LAND CRUISER/LAND CRUISER PRADO

OUTLINE OF NEW FEATURES

The following changes are made for the new Land Cruiser/Land Cruiser Prado.

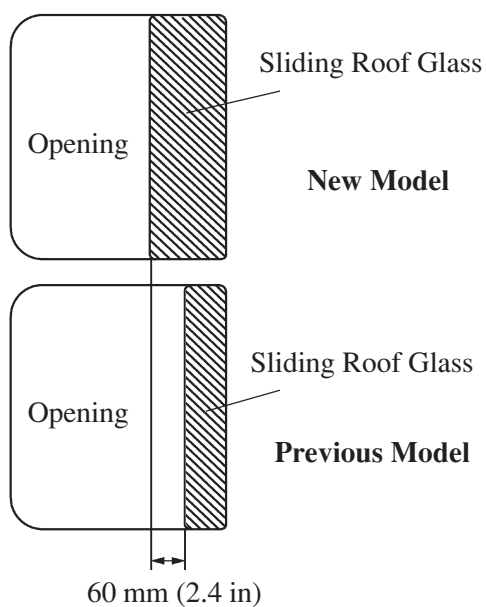
The cool box is no longer operates independently. Instead, the cool box operates in conjunction with the front air conditioner. For details on cool box operation, see the following.

Air Conditioner System	Operation
Auto air conditioner system	<ul style="list-style-type: none"> Turning the cool box switch ON also turns ON the front air conditioner system. However, turning the front air conditioner system ON does not turn ON the cool box. The front air conditioner system cannot be turned OFF when the cool box switch is ON. If the ignition switch is turned OFF when the cool box switch is ON, the front air conditioner system will also turn ON when the ignition switch is turned ON again. Turn the cool box switch OFF first to turn the front air conditioner system OFF.
Manual air conditioner system	<ul style="list-style-type: none"> The front air conditioner system must be turned ON before the refrigeration function can be turned ON*. Even if the cool box switch is turned ON, the refrigeration function will turn OFF when the front air conditioner system is turned OFF*.

*: The air is blown into the cool box, but it is not the cold air.
